SERVICE BULLETIN

№ 109EP-181

ATA 62 – INSPECTION AND REPLACEMENT OF MAIN ROTOR BLADE TIP CAP

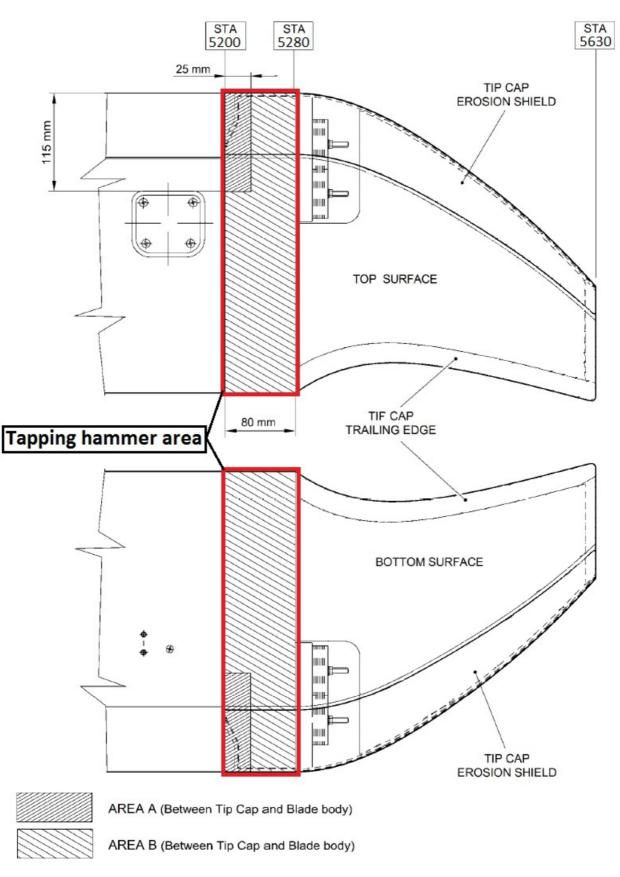
- 3. In accordance with CSPP DM CSPP-A-60-30-02-01A-913A-D and with reference to Figure 1, perform a tapping test on Main Rotor Blade Tip Cap.
 - 3.1 In case no debonding is found, proceed with step 4.
 - 3.2 In case debonding is found, check its dimensions with MM Paragraph 62-11-24 (debonding limits).
 - 3.2.1 In case debonding is found within acceptable limits, proceed with step 4.
 - 3.2.2 In case debonding is found outside the acceptable limits, apply Part II of this Service Bulletin before next flight and inform LH.
- 4. Return the helicopter to flight configuration and record for compliance with Part I of this Service Bulletin on the helicopter logbook.
- 5. Gain access to My Communications section on Leonardo WebPortal and compile the "Service Bulletin Application Communication".
